**MAJOR PROJECT ASSESSMENT:
Mixed Use Development Eastlakes Shopping
Centre, Eastlakes
(MP09_0146)**

Director-General's
Environmental Assessment Report
Section 75I of the
Environmental Planning and Assessment Act 1979

June 2013

Figure 23: 9am Shadows 21 June

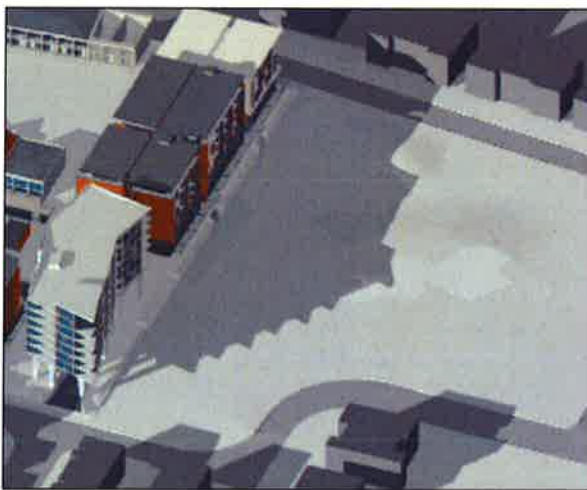
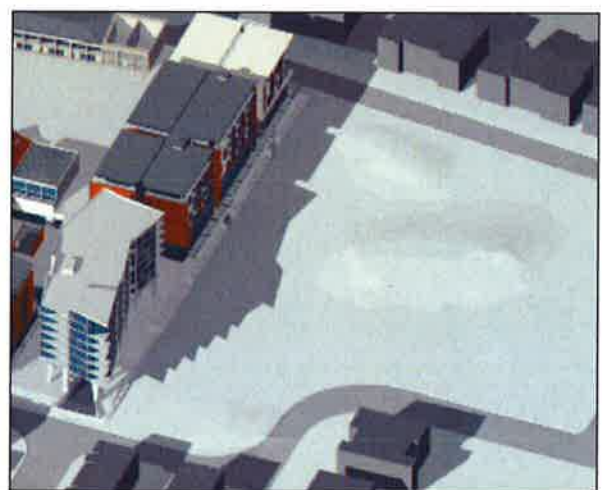
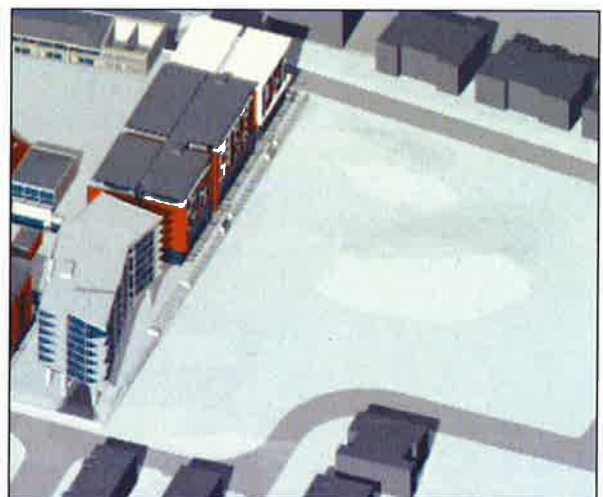
A key concern raised by the public during the exhibition period was the extent of overshadowing to Eastlakes Reserve as a result of the proposal. The proponent subsequently advised that the shadow diagrams submitted with the EA had been incorrect.

Corrected shadow diagrams submitted with the PPR demonstrate that although the proposal would result in some overshadowing of the reserve from 9.00am to 11.15am mid-winter. The extent of the overshadowing would not be significant and solar access would be retained to well in excess of 50% of the reserve area at those times. From 11.15am onwards in midwinter, solar access would be retained to the whole of the reserve and it would not be affected by the proposal (refer **Figures 23 - 26**). The Department considers that the extent of overshadowing is therefore acceptable.

Figure 31: Building separation distances at the shown first floor level.

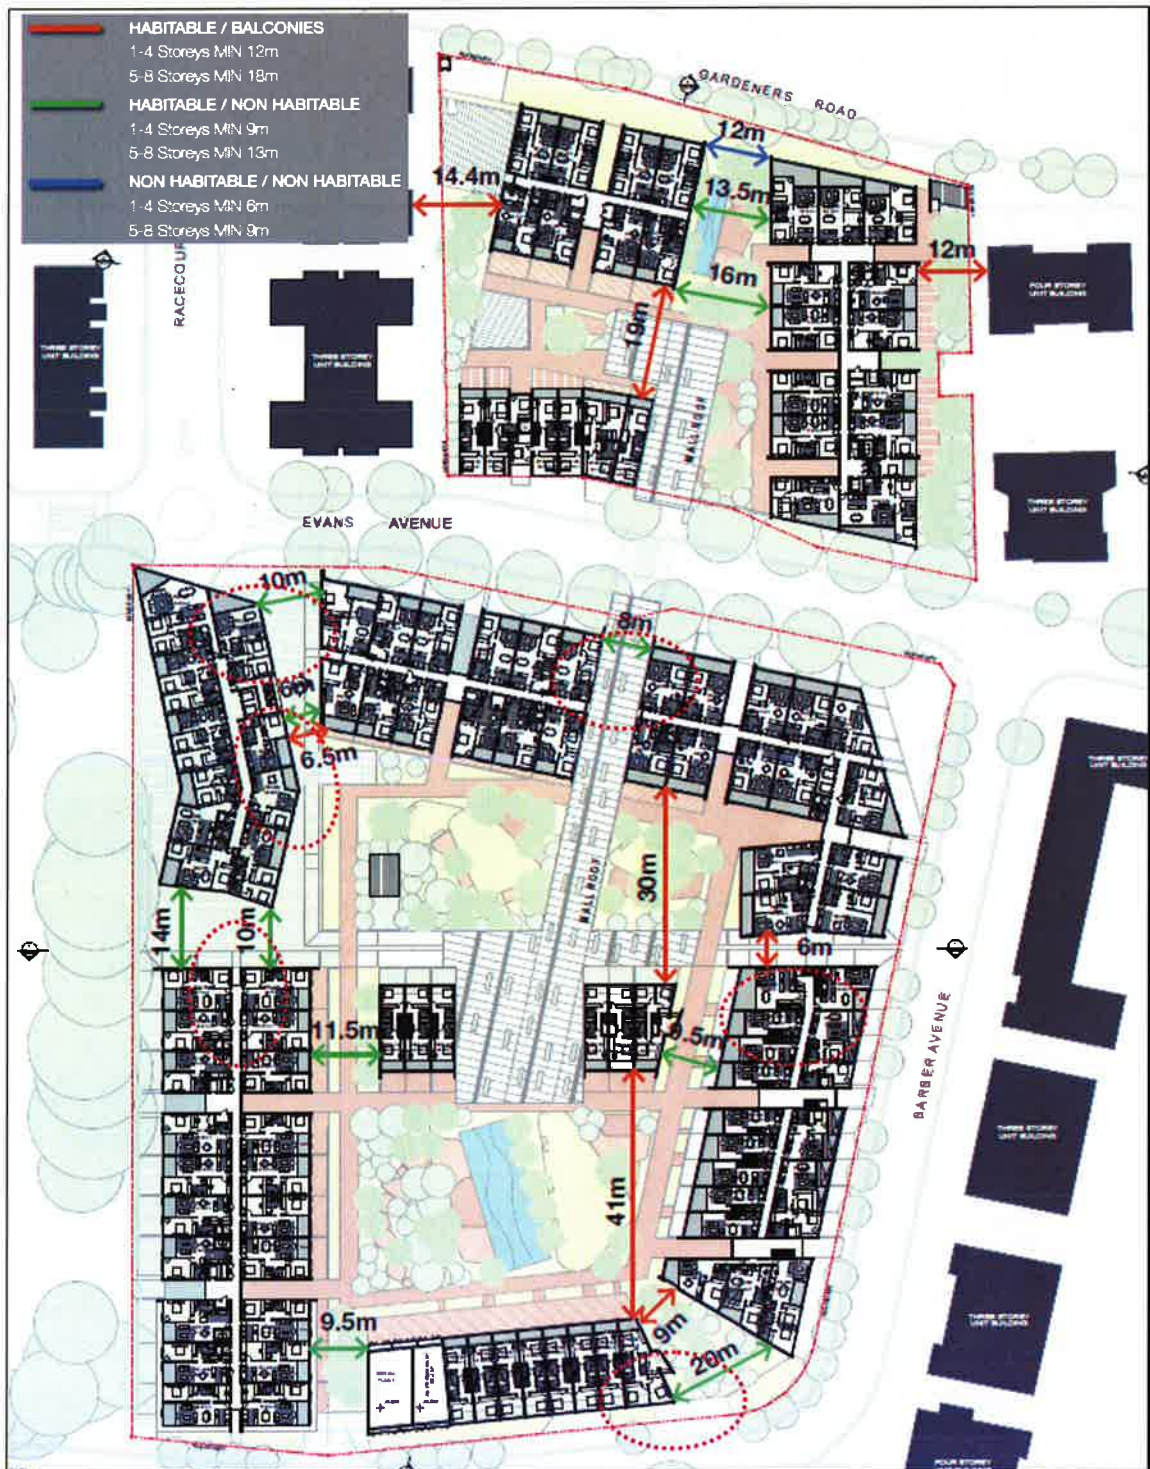
The proposed building envelopes generally provide for a range of building separation distances as demonstrated in **Figure 31**.

Non-complying setbacks.

Figure 32: Exit vehicle sight lines (shown in red) and pedestrian route around vehicle entrance (shown in blue).

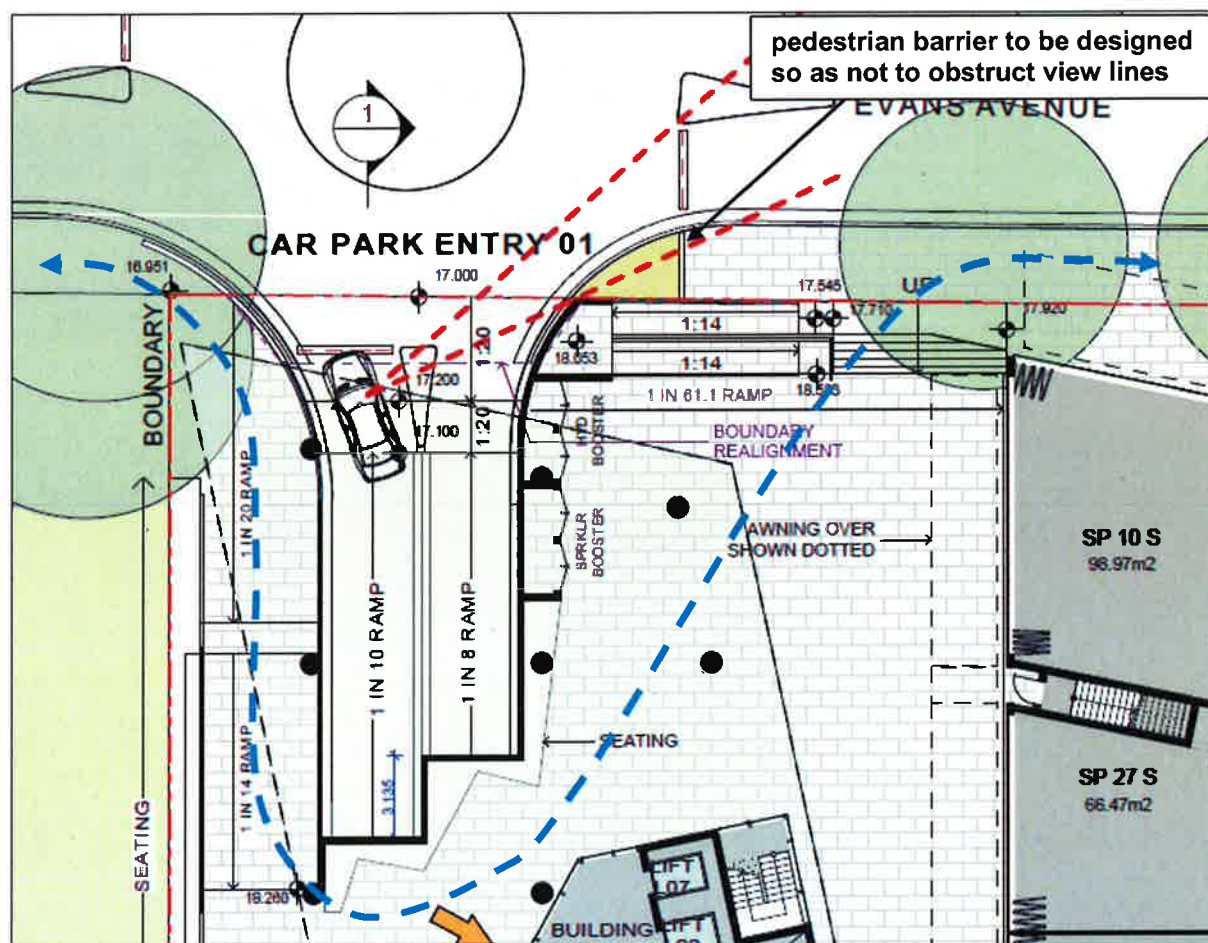
Ramp grades and sight lines for vehicles exiting the site at the Evans Avenue/Racecourse Place roundabout have also been analysed in detail and are considered to be satisfactory, with the imposition of a condition ensuring a proposed pedestrian fence does not obscure view lines (refer to **Figure 32**).

Safety in terms of pedestrian access routes were also considered. A key area of concern relates to the main vehicle entry point at the Evans Avenue/Racecourse Place roundabout. To address these concerns, the proposal has been designed to encourage pedestrians to travel around the entrance ramp and through the 'market square' rather than across the intersection. Barriers to discourage pedestrians from entering the intersection are proposed, and vehicle ramp gradients have been maximised to reduce the length of the pedestrian route (refer to **Figure 32**).

As the proposal essentially prohibits pedestrians from accessing the current footpath area and involves traversing the site, a condition is recommended requiring the provision of an easement or public right of way over the market square area.

Figure 33: Architects sketch of potential future development at 16 Evans Avenue

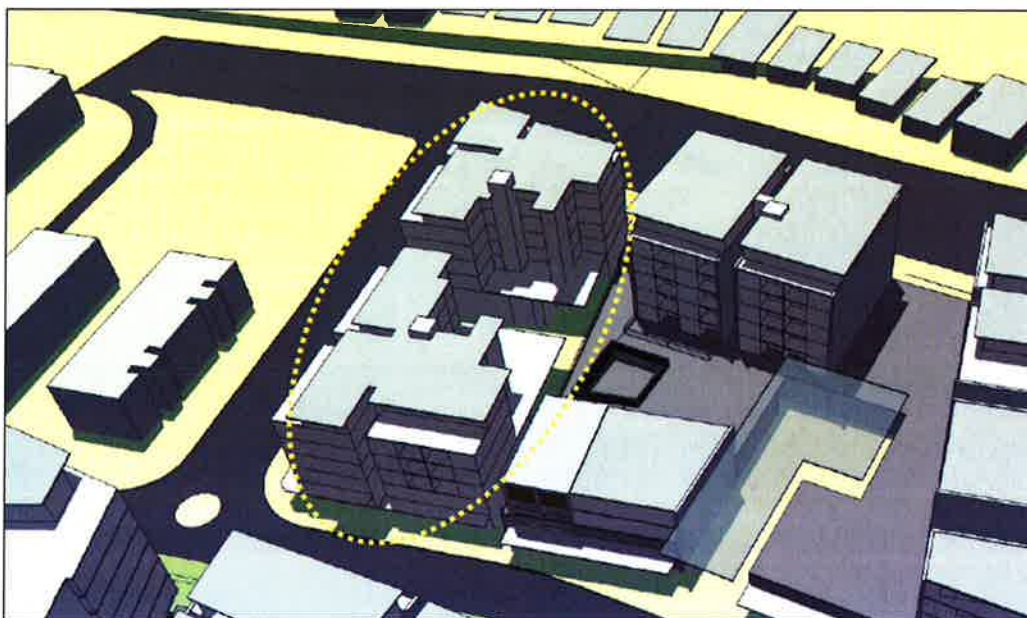
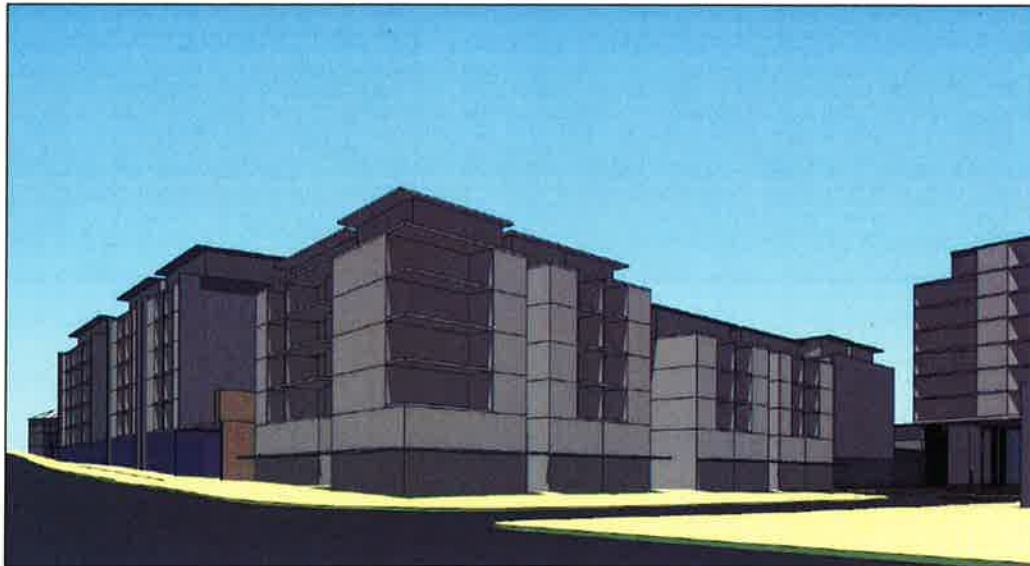
Council has questioned the accuracy and feasibility of the sketch plans and is concerned that they result in a building height and floor space ratio that would not comply with the draft Botany Local Environmental Plan 2012 controls and that no information to demonstrate the economic feasibility of the scheme has been provided.

Figure 35: Part of Gardeners Road elevation showing location of proposed signage and possible relocation of wall sign.

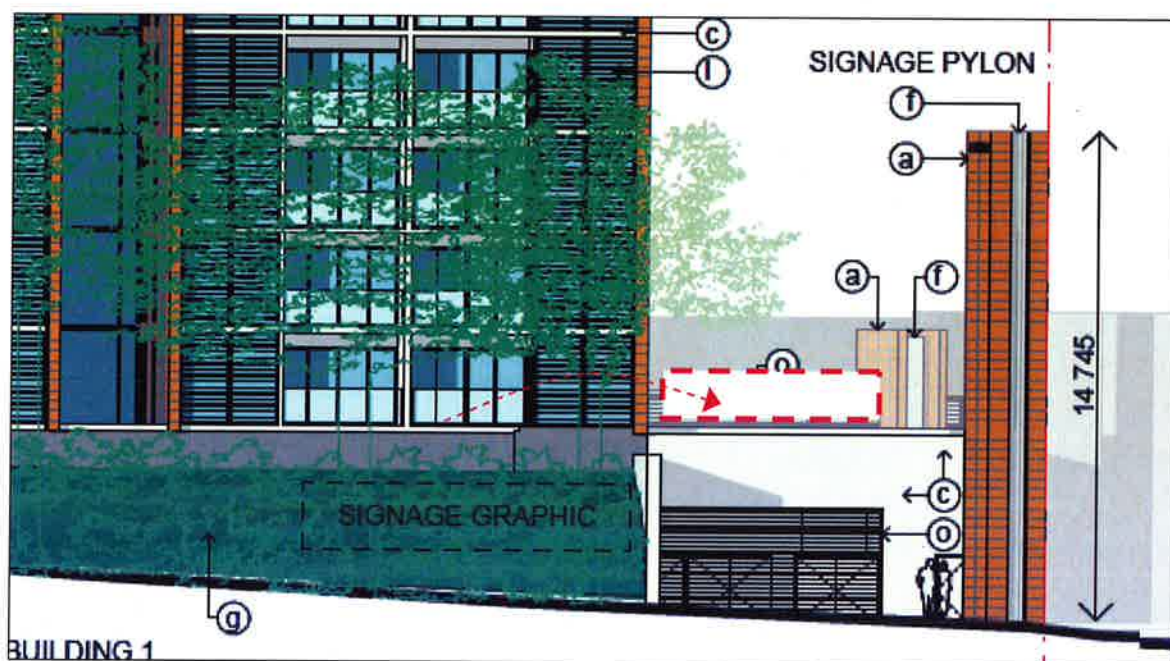
The plans indicate that the illuminated wall sign on Gardeners Road would be located within the landscaped setback area, but it is unclear which wall it would be located on. It is not considered possible to provide a visible wall sign in this location without interfering with the proposed setback landscaping and the signage would be inconsistent with the character of this section of the streetscape building which presents only residential development to the street. The sign could be located in the podium wall just to the west of the landscaped area as indicated on the plan below, without adverse impacts to the character, streetscape or landscaping. It may also make a small contribution to activating this section of street frontage which is considered to have some safety issues as discussed below. A condition is therefore included in the recommendation.

The proposed pylon sign is 2.4 metres wide and obstructs pedestrian views in this area, which is essentially a recessed dead street frontage (it includes access to substation and plant area only). The sign also would result in overbearing visual impacts at the pedestrian level. While the overall height and scale of the sign is considered to be acceptable as the main marker for the Eastlakes Town Centre entrance, the Department considers that amendments should be made at the pedestrian level to allow for a more visually open base which permits pedestrians to view through the 2.4 metre wide sign to improve pedestrian amenity and safety.
